# Several New Minor Issues Pertaining to 802.1ASbt

*IEEE 802.1 AVB TG*  
2014.01.17

- This presentation describes several minor issues related to 802.1AS that were brought to the attention of the editor since the last 802.1 meeting (November, 2013)
  - Several proposals/recommendations are made on addressing these items
- This presentation also provides the result of the action item given to the editor during the November, 2013, to look into whether making Annex E of 802.1AS (CSN) a numbered clause would be contrary to IEEE or IEEE 802 policies or would require a large effort to justify doing this
  - The editor was also given the action item to update [1]
    - This has been done; revision 1 [1] has been prepared for the current meeting

# Issue 1 - 3

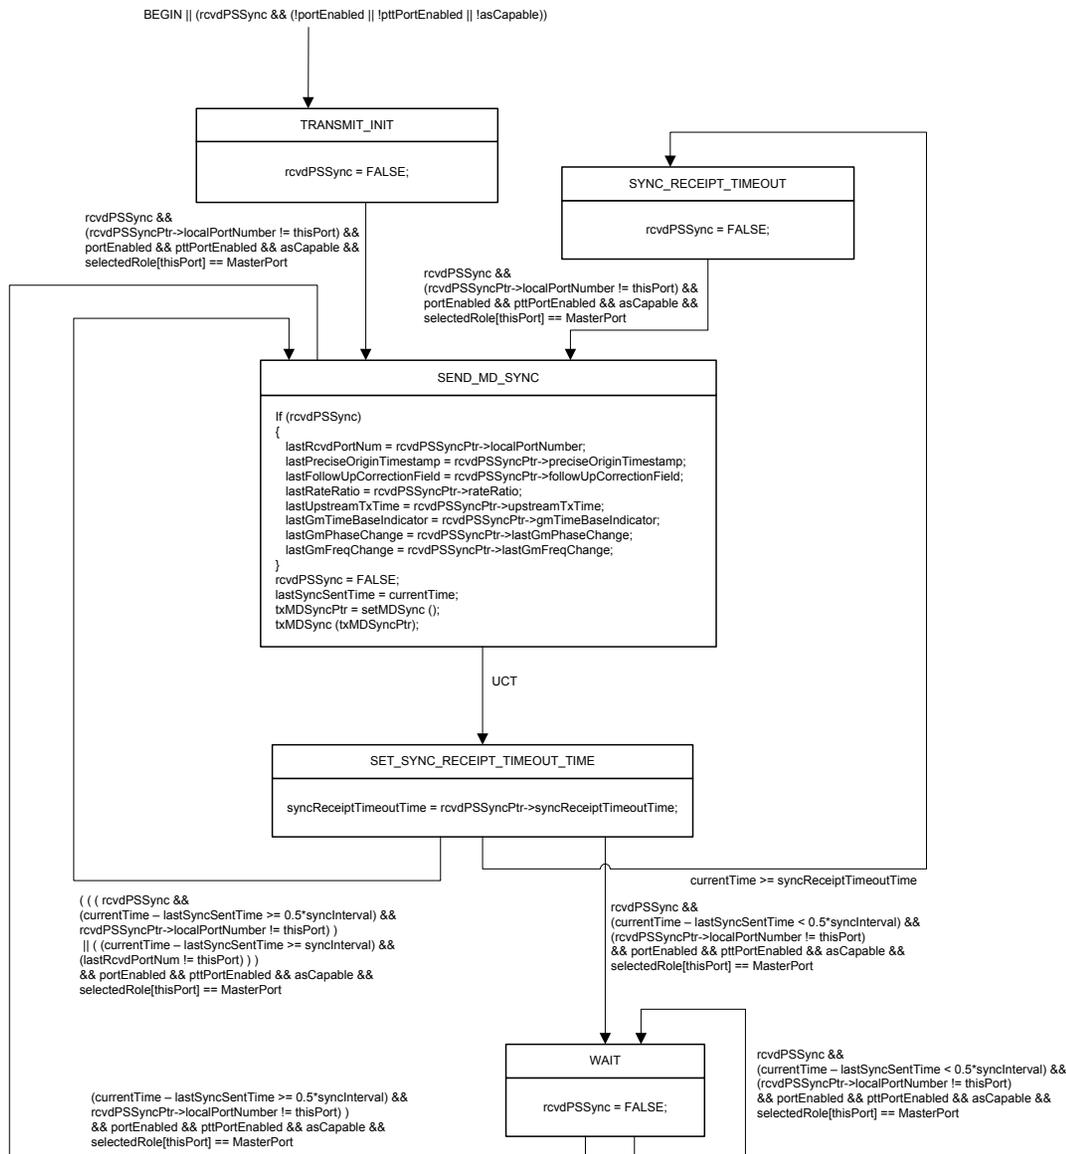
- This issue relates to potential continuous cycling of the PortSyncSyncSend state machine (SM) if a Sync message is received less than  $\frac{1}{2}$  Sync interval since the last Sync message was received
  - This issue was pointed out to the editor by [2]
- Consider the PortSyncSyncSend state machine, shown on the next slide (taken from Figure 10-8 of 802.1AS – 2011)

❑ Suppose the state machine is in the SET\_SYNC\_RECEIPT\_TIMEOUT\_TIME state waiting for a Sync message, and a Sync message is received before  $\frac{1}{2}$  Sync interval has elapsed since receipt of the last Sync message

❑ In this case, rcvdPSSync is TRUE, and  $currentTime - lastSyncSentTime < 0.5 * syncInterval$

- ❑ In that case the rightmost branch, which cycles back to the SET\_SYNC\_RECEIPT\_TIMEOUT\_TIME state, is taken
- ❑ However, rcvdPSSync is not set to FALSE
- ❑ As a result, this transition continues to occur (as long as portEnabled, pttPortEnabled, asCapable, and other conditions in the branch remain TRUE)
- ❑ This cycling continues until  $\text{currentTime} - \text{lastSyncSentTime} \geq 0.5 * \text{syncInterval}$
- ❑ This behavior is not desired (among other things, if this were followed exactly it would needlessly use CPU cycles and power)
- ❑ A proposed modification to the SM to eliminate this problem is shown on the next slide
- ❑ A new state, WAIT, is added, in which rcvdPSSync is set to FALSE
- ❑ The SM waits in this state until  $\text{currentTime} - \text{lastSyncSentTime} \geq 0.5 * \text{syncInterval}$ 
  - At that point, the SM transitions to the SEND\_MD\_SYNC state

# Issue 1 - 5

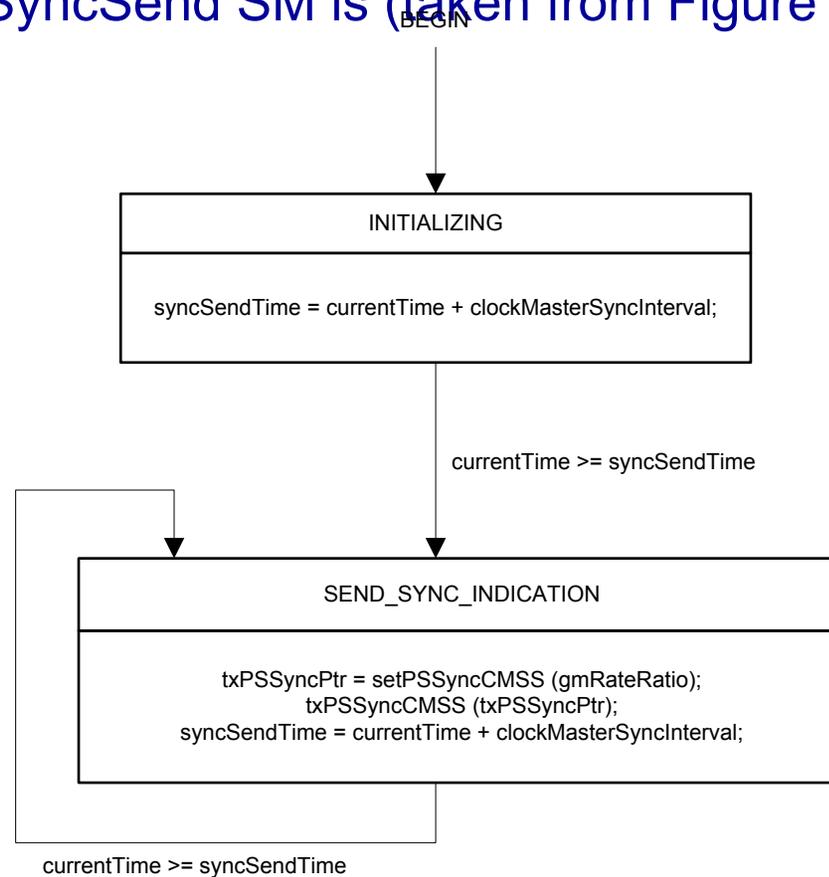
❑ If a new Sync message is received while waiting, the SM transitions once back to this state and sets rcvdPSSync to FALSE

❑ It is proposed to replace the existing PortSyncSyncSend SM (Figure 10-8) with the SM on this slide

# Issue 2 - 2

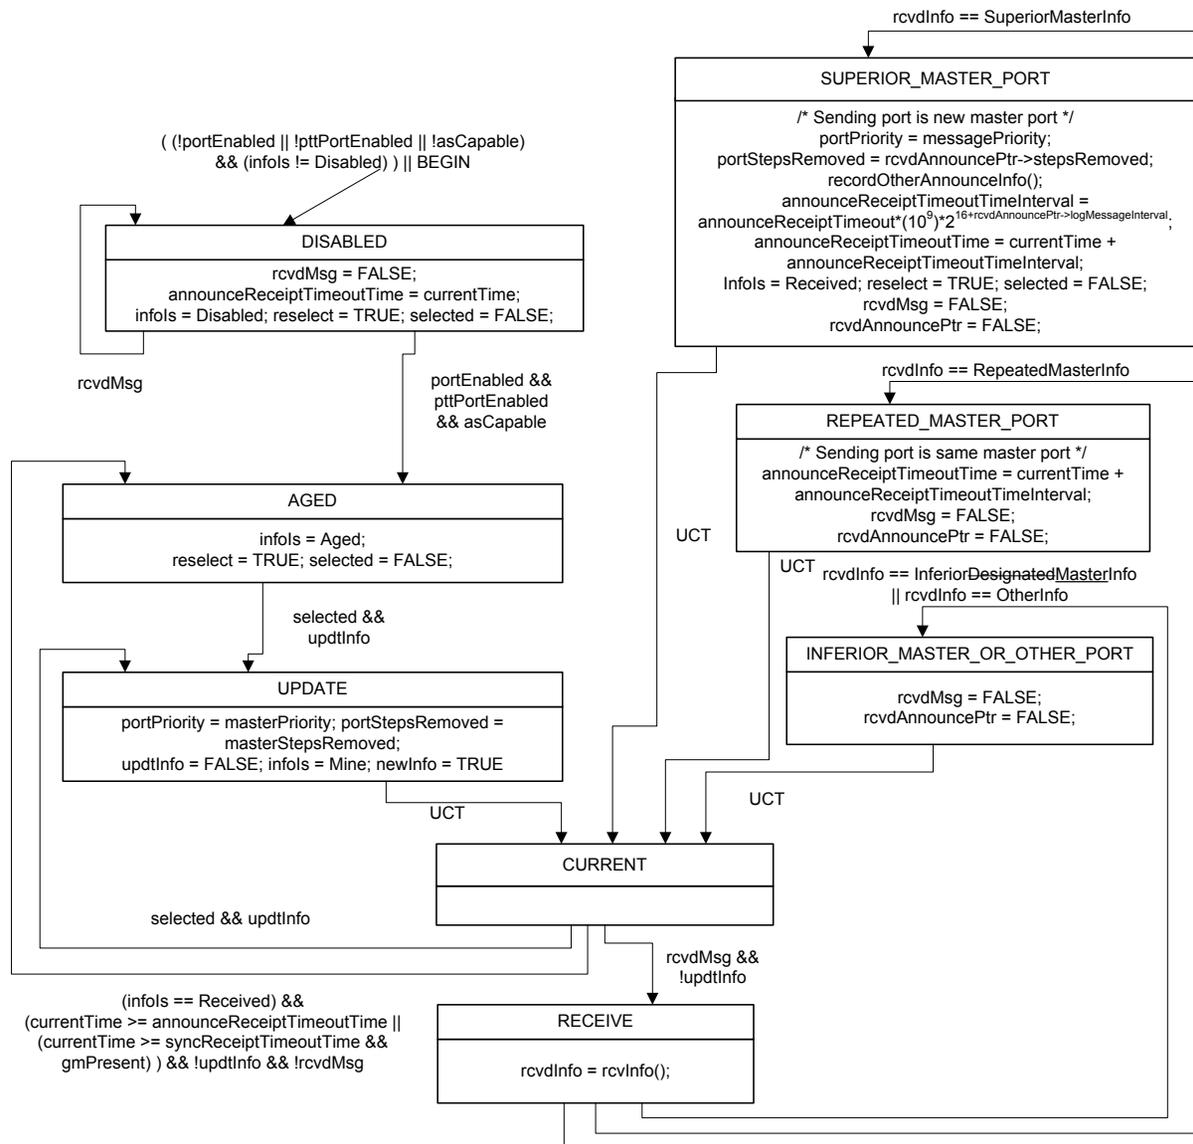
□ Consider the PortAnnounceReceive state machine below (taken from Figure 10-12 of 802.1AS-2011) PortAnnounceInformation state machine, shown on the next slide (taken from Figure 10-13 of 802.1AS-Cor1 – 2013)

- **However, a new syncReceiptTimeoutTime is not set**
    - SyncReceiptTimeoutTime is set by the PortSyncSyncSend SM when a Sync message is sent (see slides 6 and 8)

- ❑ However, consider the case where an Announce message is received from a clock (time-aware system) that is better than the current GM, and that clock becomes the new GM, but for some reason it never sends a Sync message

- It would appear that this problem could be fixed by simply setting the syncReceiptTimeoutTime in the SUPERIOR\_MASTER\_PORT state of the PortAnnounceInformation SM

- ❑ This behavior seems incorrect and, in any case, with the proposed fix of setting syncReceiptTimeoutTime in the SUPERIOR\_MASTER\_PORT state would cause it to be set whenever an Announce message is received (whereas it would be desired to set it in this state only when the GM first becomes GM
